The contact spring on FEU finger grip carrier and FEU (Grip) carrier for 6.3x32mm fuse is improved.

Product Change Notification					FEU fingergrip improvement		
owner	creation date	release date	released by	change order no	rev	page	D10-016-241
dislercy	08.06.2017	21.12.2017	haeckima	2013038	A	1 of 1

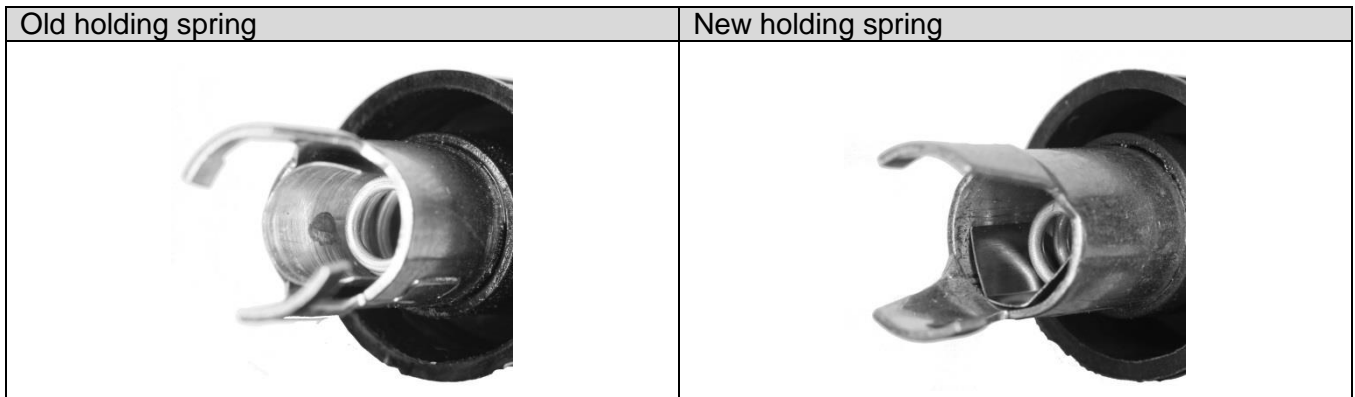
- Improved electrical contact
